HOLDOVER

BARNES SUBDIVISION

APPLICATION NUMBER Holdover DATE January 6, 2005
APPLICANT Barnes Subdivision
REQUEST Subdivision

BARNES SUBDIVISION

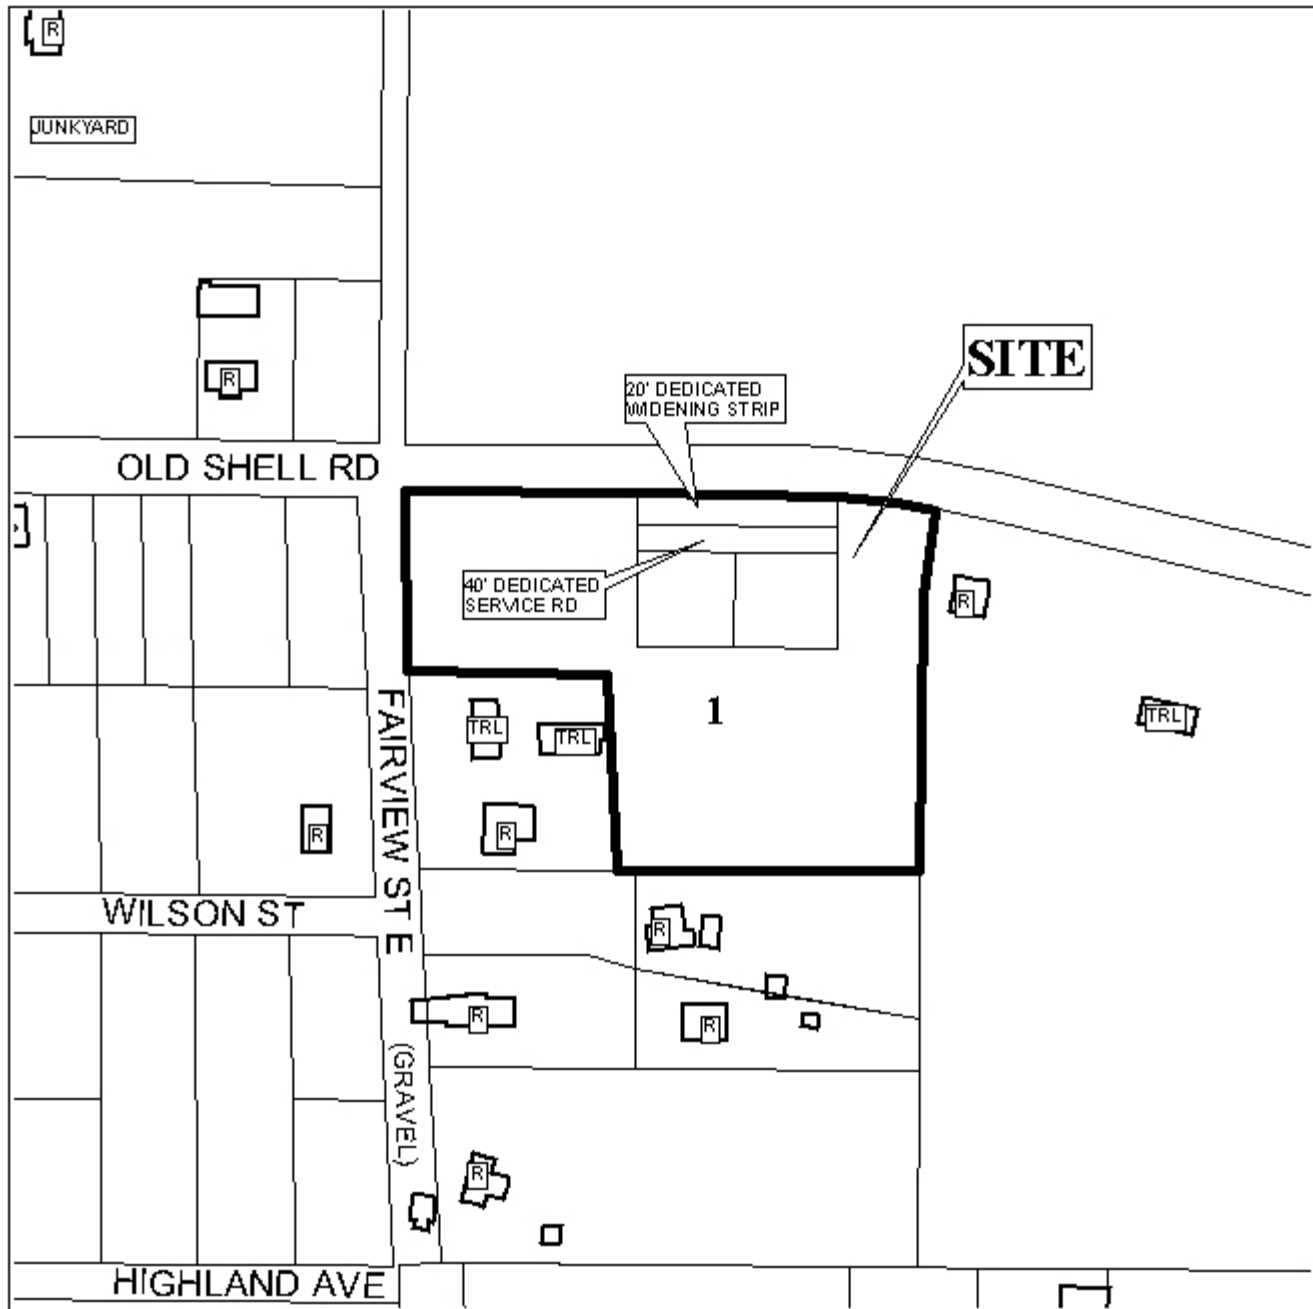
Engineering Comments: Must comply with the Mobile County Flood Damage Prevention Ordinance.

The site fronts Old Shell Road, a planned major street, and the existing right-of-way is shown as 60-feet. The Major Street Plan requires a 100-foot right-of-way; therefore, the dedication of sufficient right-of-way to provide 50-feet from the centerline of Old Shell Road should be required. Additionally, as a means of access management, the placement of a note on the final plat stating that the number, location, size, and design of all curb cuts to Old Shell Road must be approved by County Engineering, should be required.

It should be noted that when the two existing lots of record were recorded, 20' was dedicated for future widening, and 40-feet was dedicated for service road. At this point, the 40-foot service road is no longer needed, and if a vacation request for the 40-foot service road right-of-way was approved, the 40-feet could be incorporated into the site.

Fairview Road has an existing right-of-way of 40-feet and as such is substandard in width; therefore, the dedication of adequate right-of-way to provide 25-feet from the centerline should be required.

The 25-foot minimum building setback lines along Old Shell Road and Fairview Street East are not shown but would be required on the final plat (this would be from the dedication). Additionally, as the site is a corner lot, the dedication of a 25' radius should be required.

This site is located in the County, thus a note should be placed on the final plat stating that any lots which are developed commercially and adjoin residentially developed property must provide a buffer, in compliance with Section V.A.7. of the Subdivision Regulations.

The plat meets the minimum requirements of the Subdivision Regulations and is recommended for Tentative Approval subject to the following conditions: 1) the dedication of sufficient right-of-way to provide 50-feet from the centerline Old Shell Road; 2) the dedication of a 25-foot radius at the corner of Old Shell Road and Fairview Street East; 3) the placement of a note on the final plat stating that the number, location, size, and design of all curb cuts to Old Shell Road must be approved by County Engineering; 4) dedication of adequate right-of-way to provide 25-feet from the centerline of Fairview Street East; 5) the placement of a note on the final plat stating that any lots which are developed commercially and adjoin residentially developed property must provide a buffer, in compliance with Section V.A.7. of the Subdivision Regulations; and 6) the placement of the 25-foot minimum setback lines on the final plat (from the dedications).
